Twin Falls Historic Preservation Commission Agenda

Date: Monday, August 3, 2026
To: Historic Preservation Commission
From: Lisa Strickland, City Planner

Request for a Certificate of Appropriateness for exterior windows and doors on property located at 250 Main Avenue North. (PZ26-0087)

Request for a Certificate of Appropriateness for proposed new signs on property located at 147 Main Ave E. c/o Lytle Signs on behalf of Verin Properties, LLC PZ26-0095

Request # 4- Wall Sign

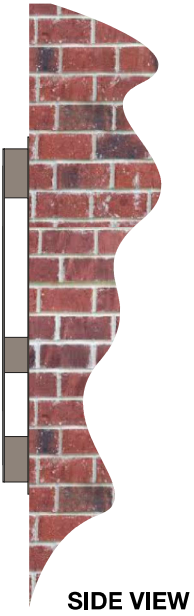
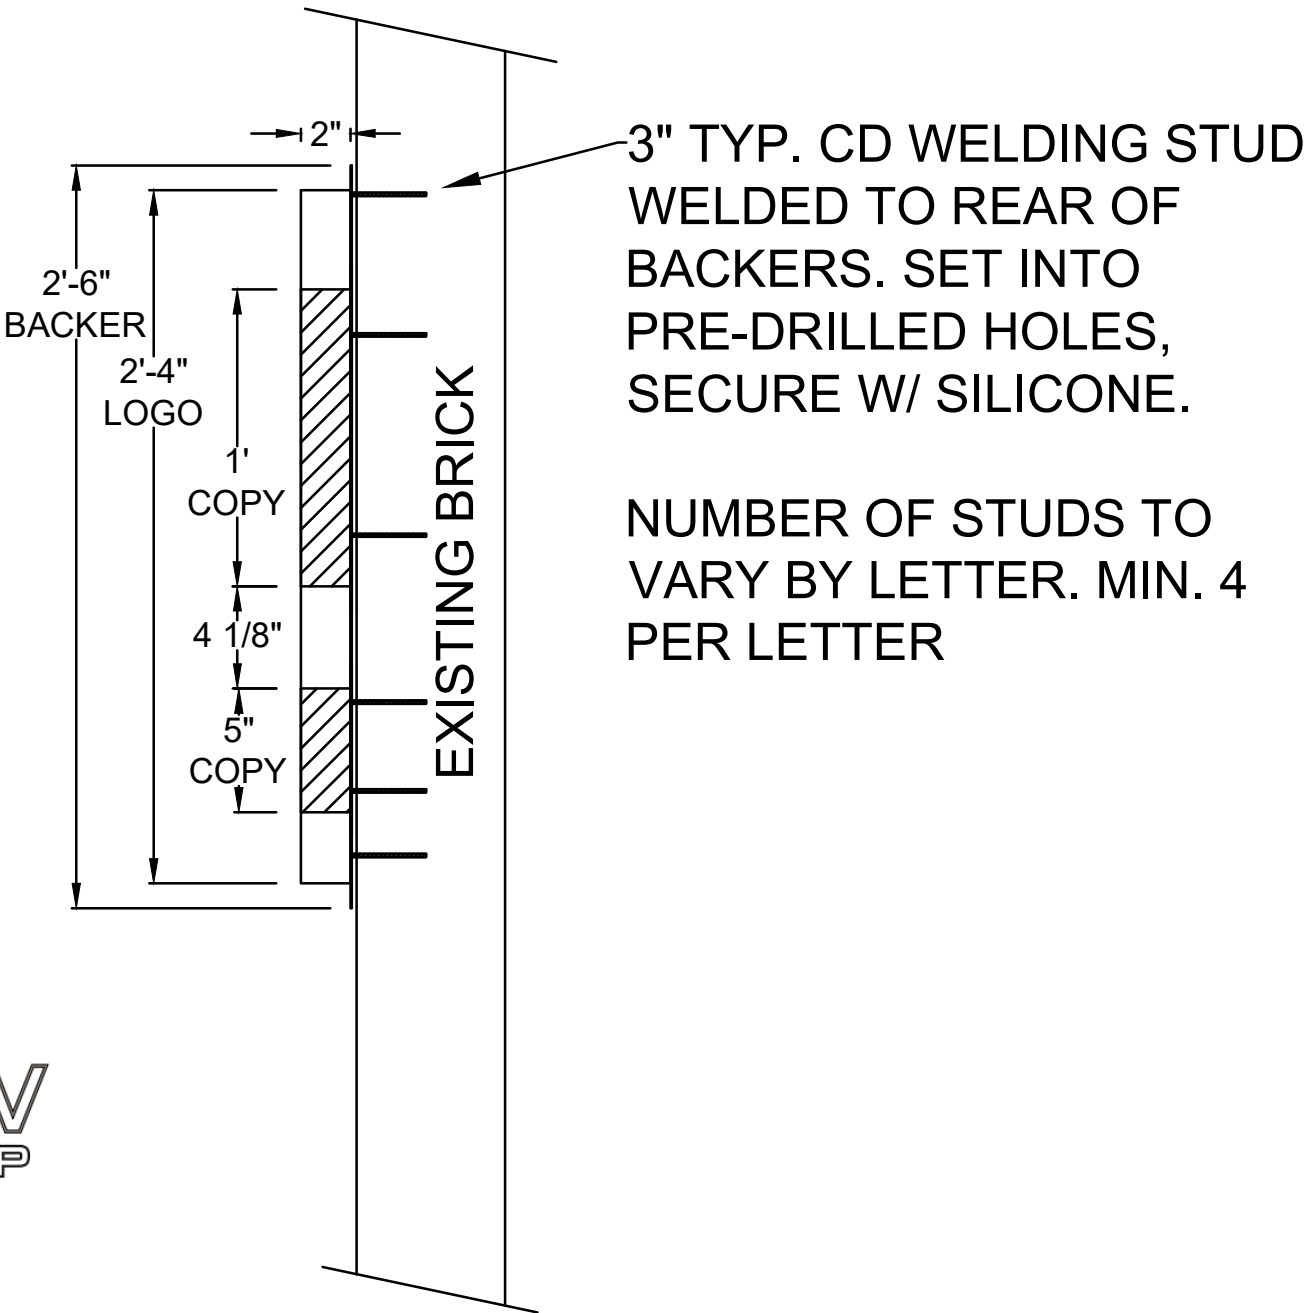
4-Wall Sign

The fourth and final proposal is to remove the existing wall sign located on the east side of the building. The proposed wall sign fits within the architectural elements of the facade about the windows and is appropriately sized for the building. The sign will not be illuminated and should not overpower the architectural features of the building. The proposed sign could be found to be compatible with the guidelines.

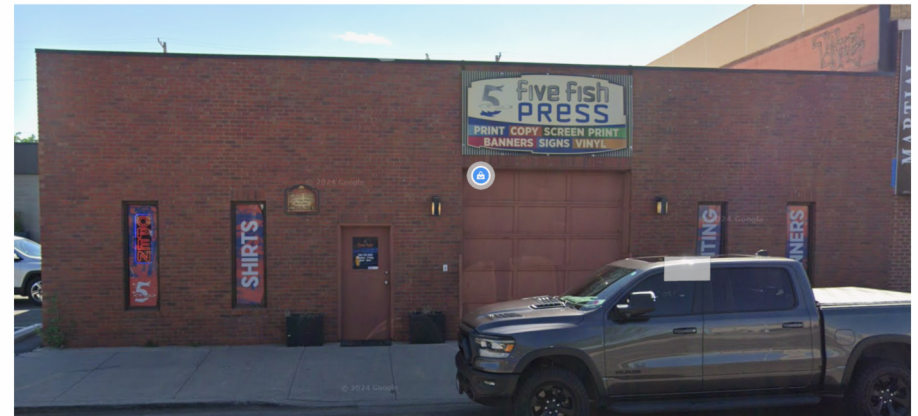
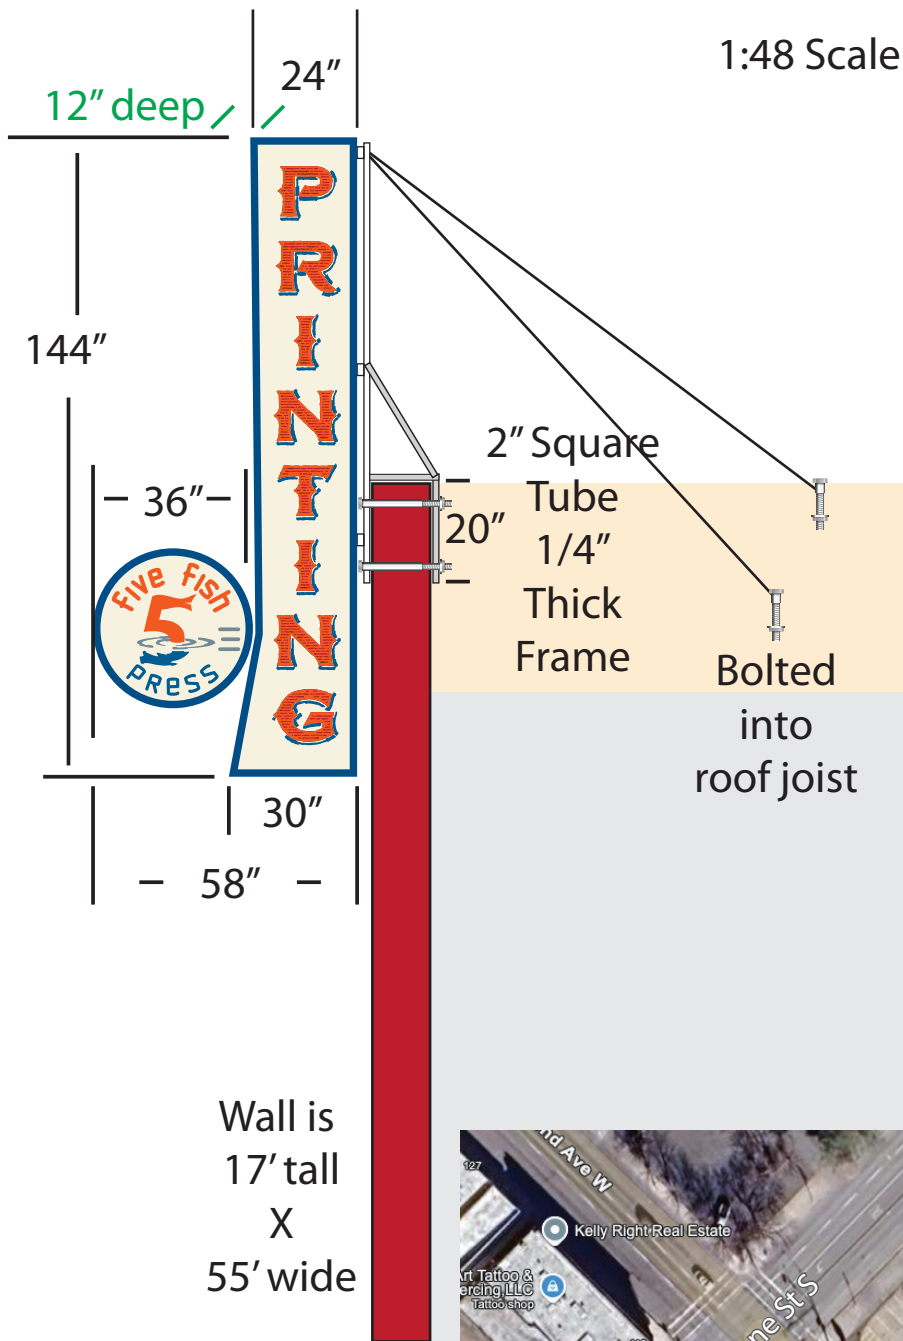
The applicant is requesting approval to install a non-illuminated double-sided projecting sign to the front of their building located at 146 2nd Ave S. The sign measures approximately 12 ft and would project above the roofline. The support structures consist of a welded street tube frame anchored into the roof framing. The applicant has included elevated drawings with the mounting details. The guidelines for the downtown district encourage signs to be designed to enhance the architectural character of the building. The signs should fit within the architectural elements of the facade and maintain a pedestrian scale. The design guidelines do state it is generally not appropriate to install roof-mounted signs. The proposed sign is somewhat of a hybrid with a portion projecting from the front of the building and a portion projecting above the roofline. However, the installation of the sign does show it being attached to the roof. The sign is proposed to be 12' tall, which could seem disproportionate to the front of the building.

The material appears to be a painted steel frame, a painted sign cabinet with non-illuminated graphics. These materials are generally compatible with the guidelines and appropriate for the district. The guidelines discourage internally illuminated signs. The applicant has not proposed that the sign be illuminated. If approved, staff would recommend that the sign cannot be illuminated.

Staff has found that the sign does not fit within the architectural features of the building's facade and may dominate the building visually. However, the sign is on point for the period of significance for the building.

1. Subject to site plan amendments as required by City Code Standards.
2. Subject to the applicant obtaining permits as required by City Code Standards.
3. Subject to the sign not being illuminated.
